**GULF STATES UTILITIES COMPANY**

July 31, 1986  
RBG- 24,131  
File No. G9.5

River Bend Station - Unit 1  
Docket No. 50-458

Gulf States Utilities (GSU) January 23, 1985 letter (RBG-19,972) transmitted GSU's final updated response to containment issues. Your review and remaining open items are documented in Supplement No. 2 - Appendix K of the River Bend Station Safety Evaluation Report (NUREG-0989), a June 25, 1985 letter from H. R. Denton to W.J. Cahill requesting additional information, and NPF-47 License Condition 2.C.(5). The enclosure to this letter is GSU's response to these open Mark III related issues.

PIPING CONFIGURATION FOR  
RHR H<sub>x</sub> RELIEF VALVE DISCHARGE  
LINE-A      FIGURE 8-1

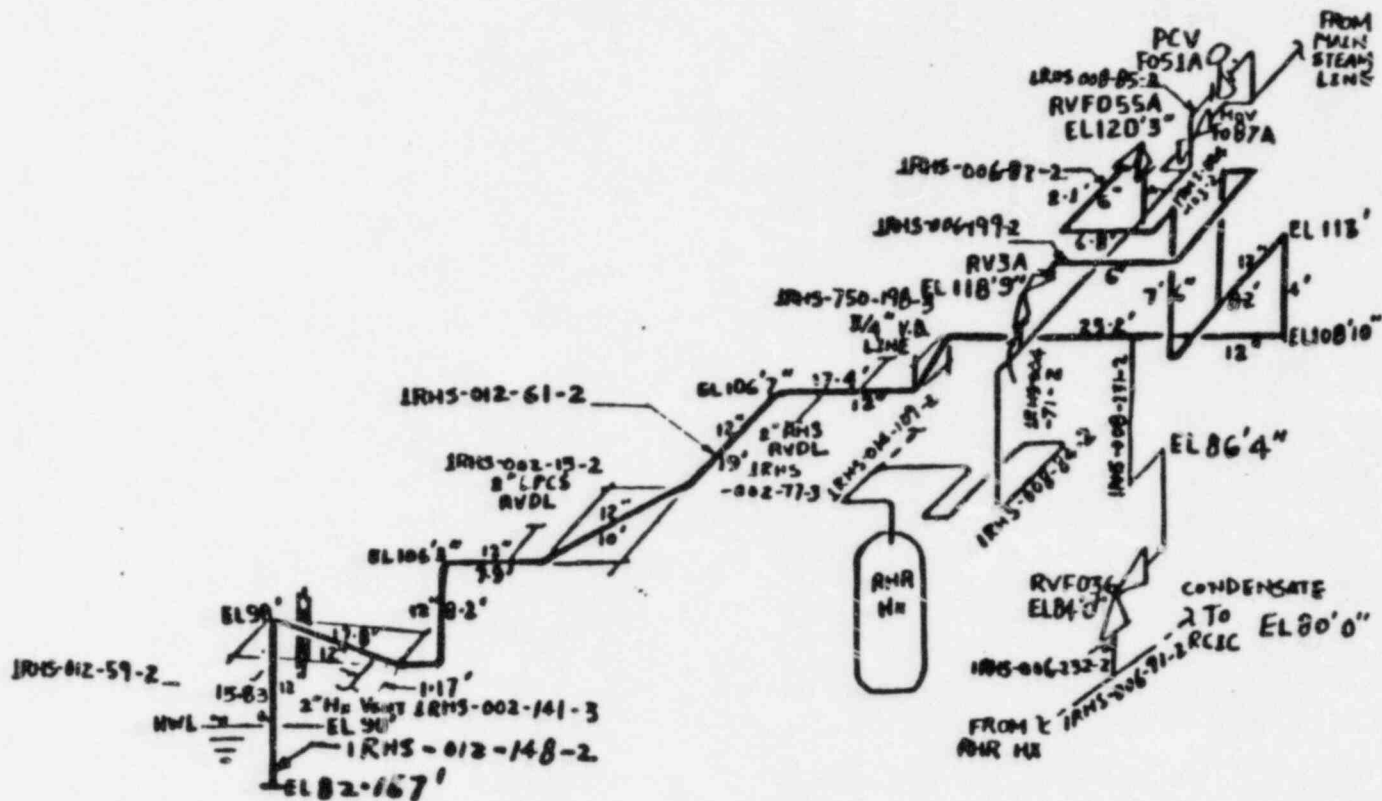
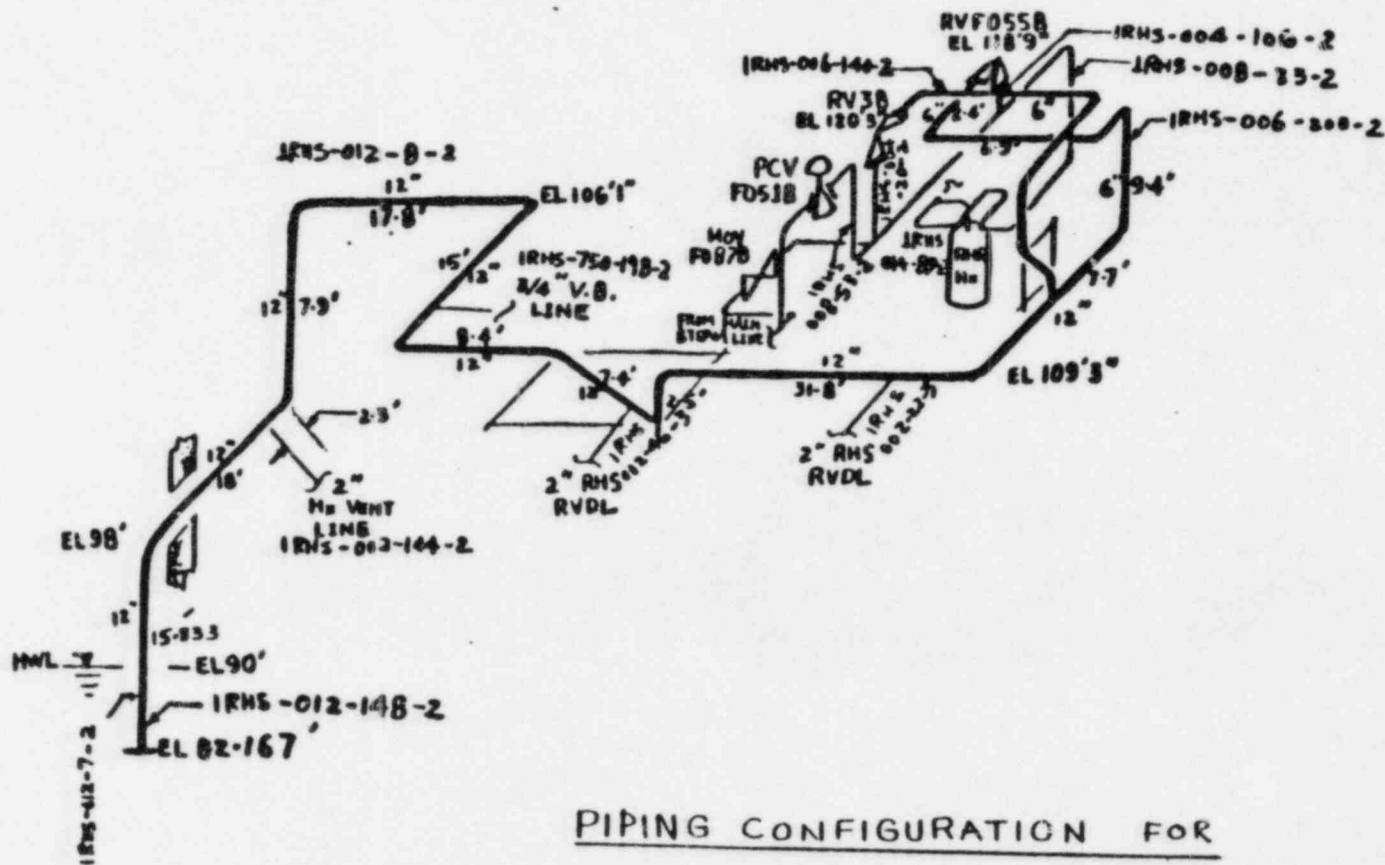
The reflood model developed in the Mark I and Mark II program (Reference 1) was used to calculate the water rise in the RHR heat exchanger relief valve discharge line. Following valve closure, the steam/water interface heat transfer coefficient used in the reflood analyses was scaled from vertical vent flow test data (Reference 2). In the vicinity of the pipe exit, a maximum value of heat transfer coefficient was used, considering total bubble collapse. Inside the pipe, the heat transfer coefficient was chosen based on the bubble surface value. The heat transfer coefficient has also been adjusted to account for the influence of the air accumulated from the vacuum breaker near the steam/water interface (References 1 and 3). SWEC computer code STEHAM (FSAR Appendix 3A) was used to calculate dynamic load on piping due to subsequent relief valve actuation. Subsequent actuation was postulated to occur at the maximum reflood level to determine the worst scenario load. The RHR discharge lines have been qualified to these dynamic loads.
